Monitoring Year 4 of 5

Project Name: Junes Branch Stream Restoration

RE: Junes Branch Stream Restoration Site: MY4 Monitoring Report (NCDMS ID 95027)

Listed below are comments provided by DMS on January 11, 2018 regarding the Junes Branch Stream Restoration Site: Year 4 Monitoring Report and RES' responses.

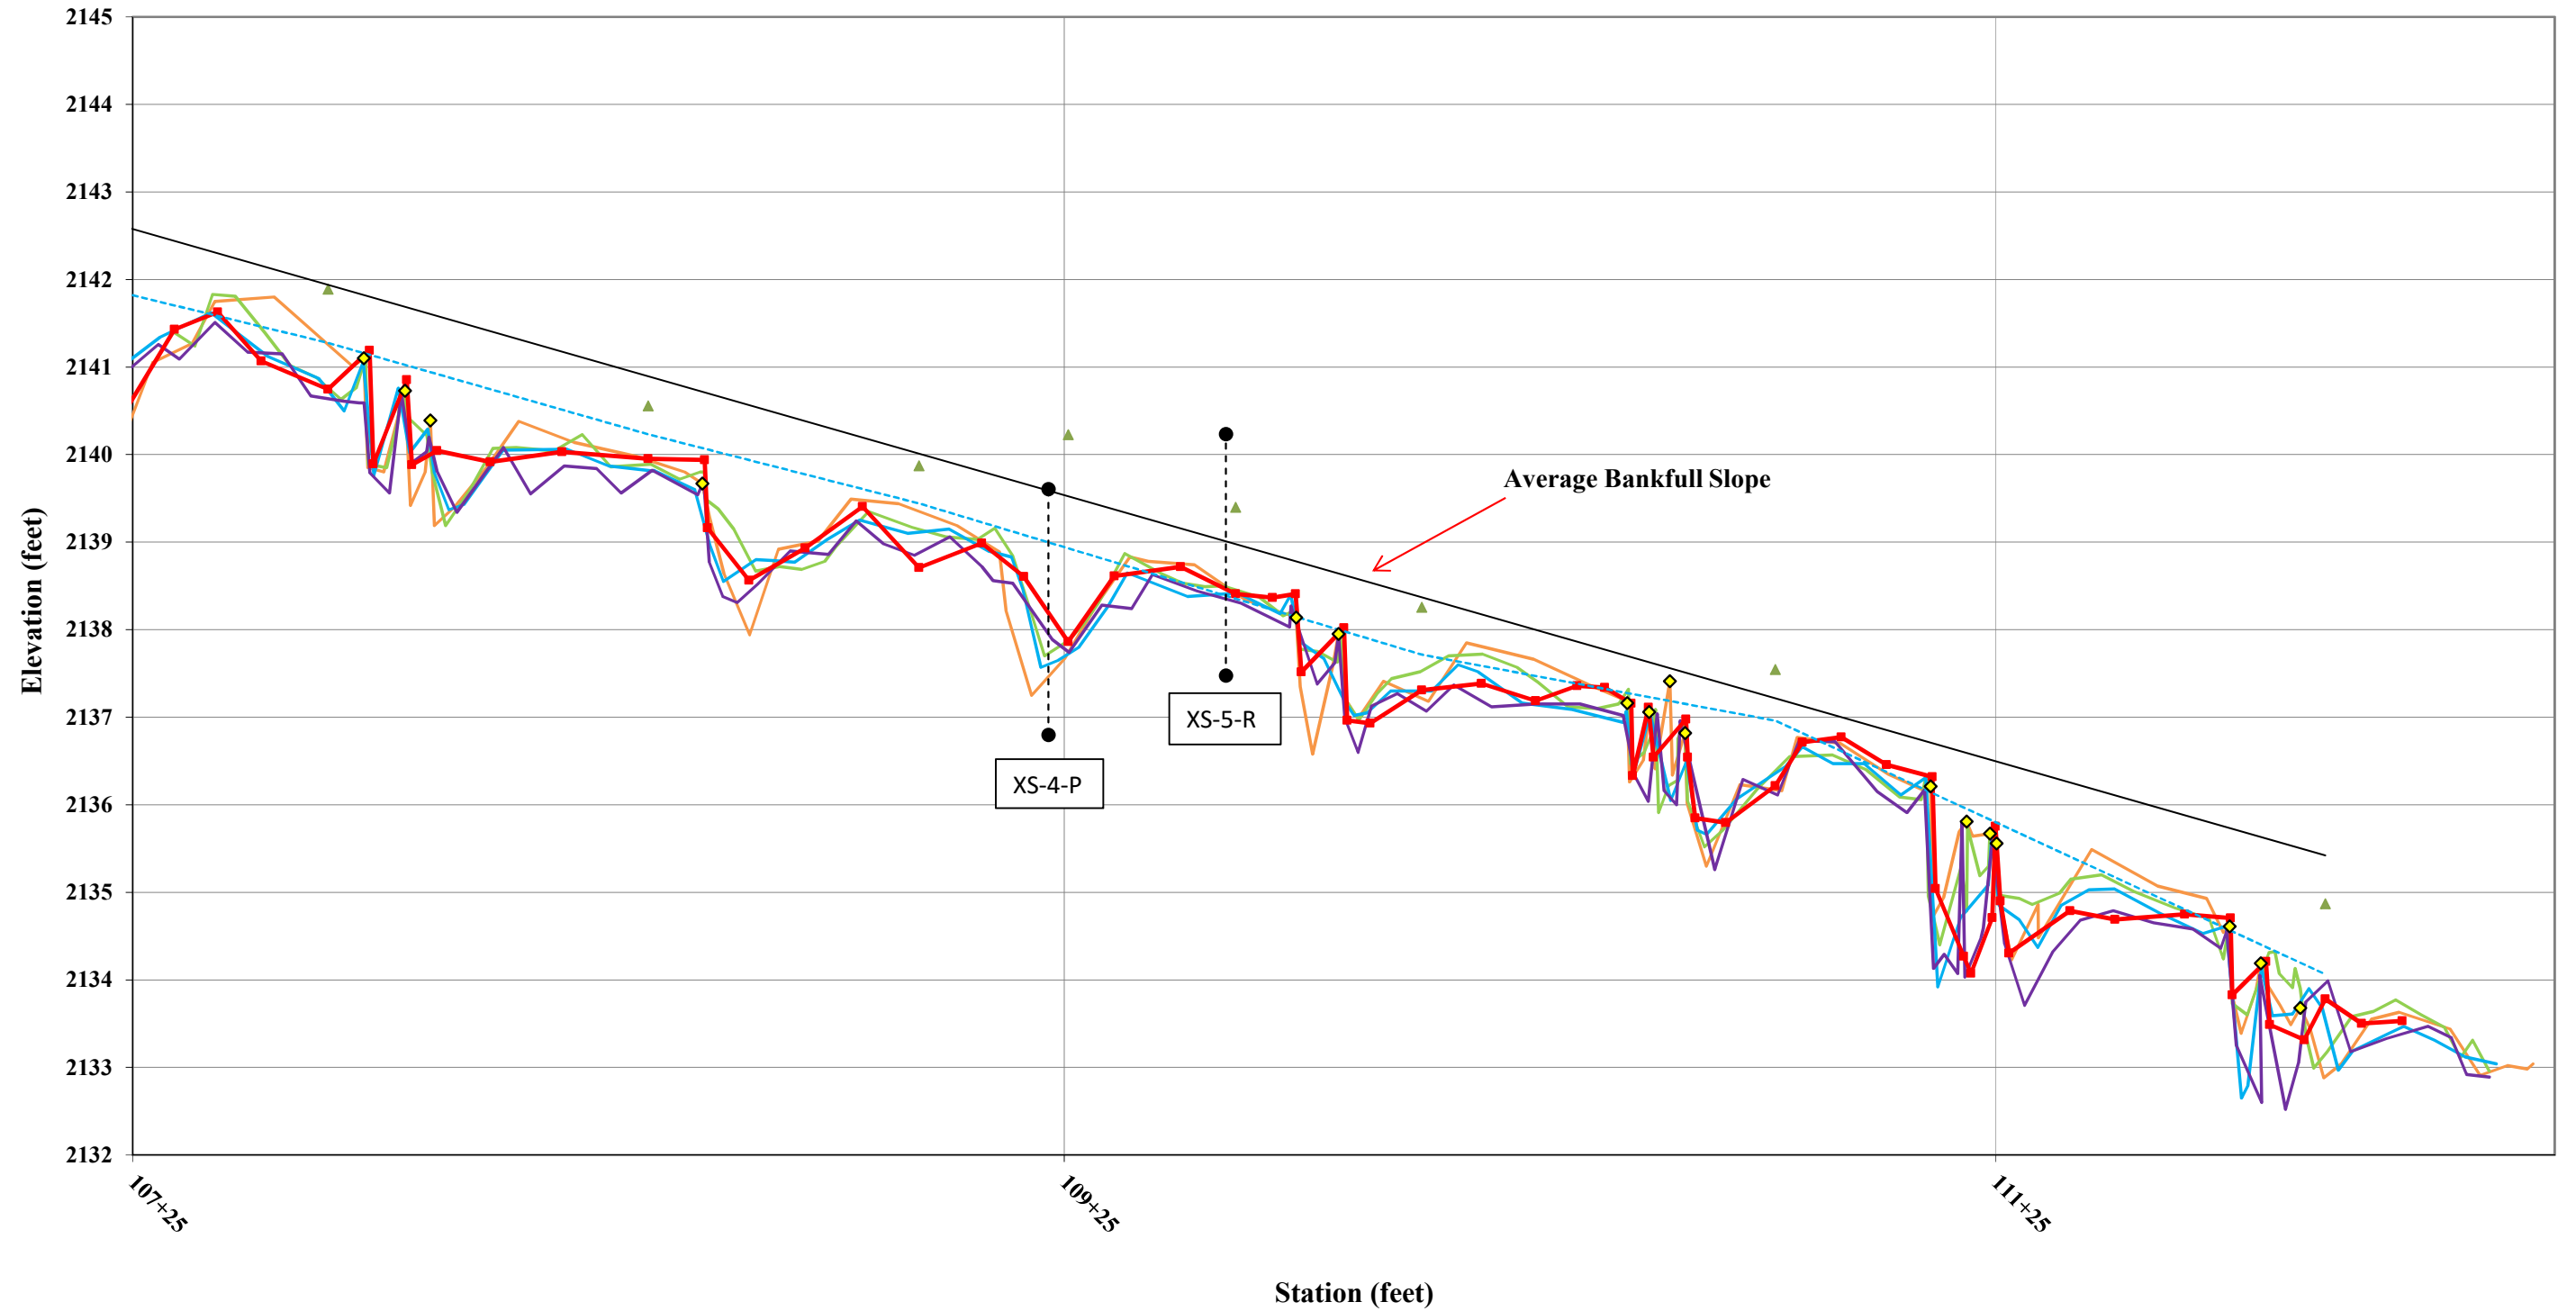
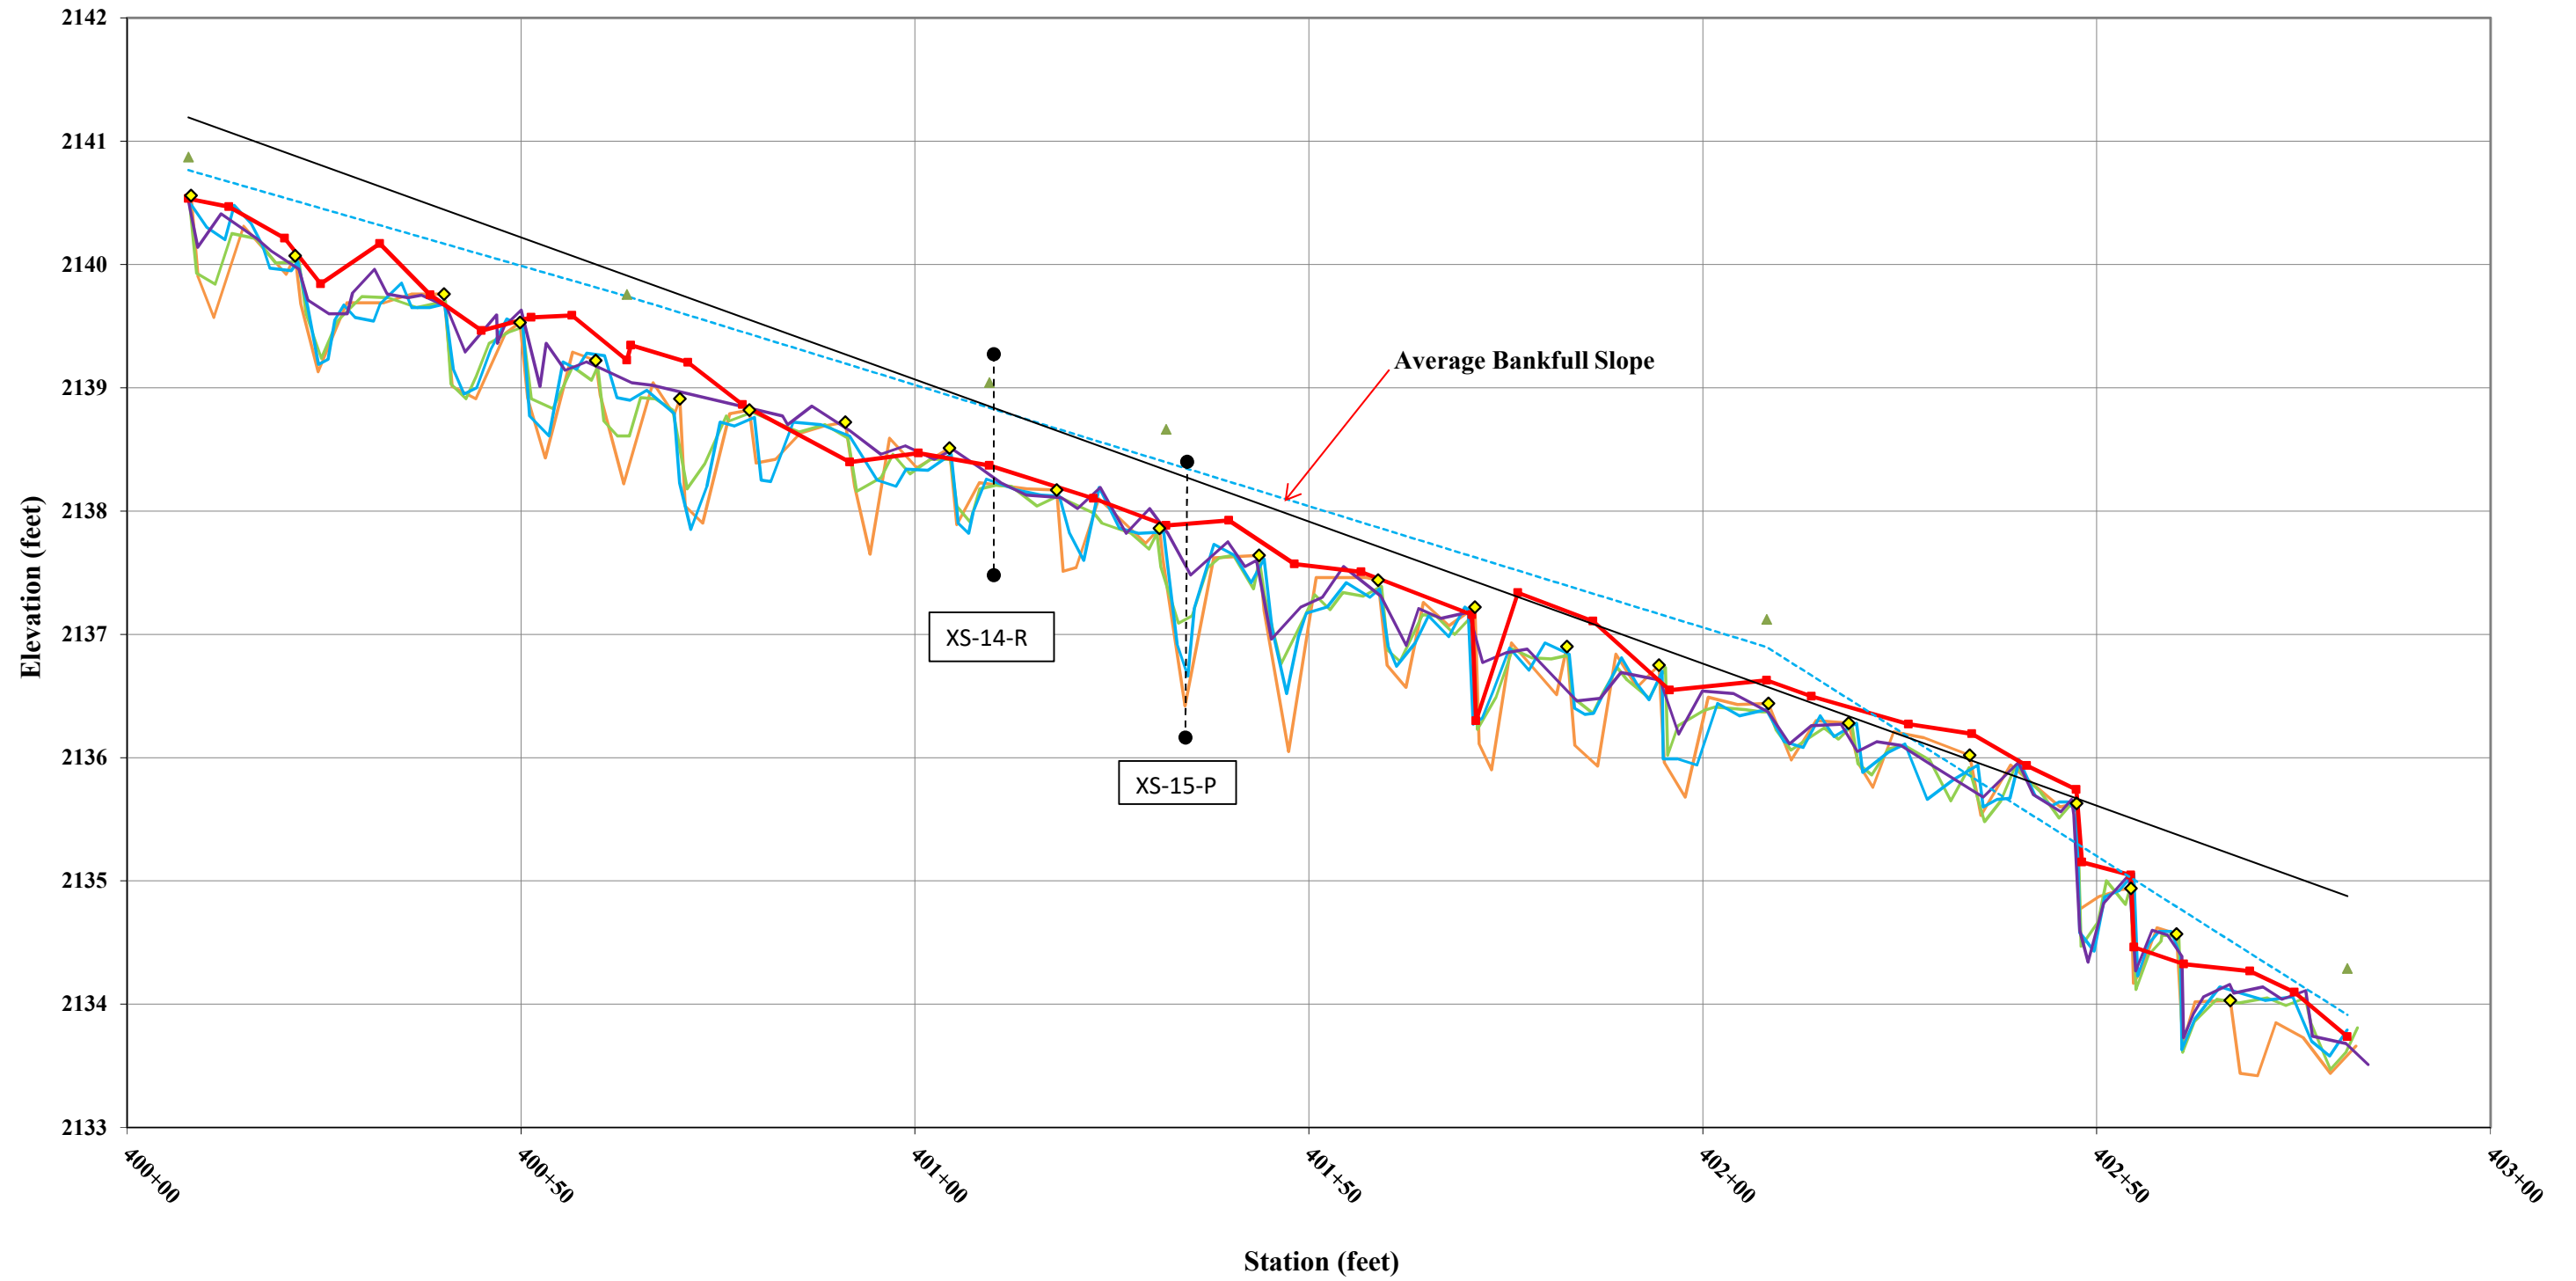
Longitudinal Profiles – Per the approved mitigation plan, longitudinal profiles are required annually as part of the project monitoring. The project longitudinal profiles were not included in the draft report; however, they were included in the digital support files. Please include the MY4 longitudinal profiles in the FINAL MY4 report and QA/QC the associated data and tables.
[Done.](#)
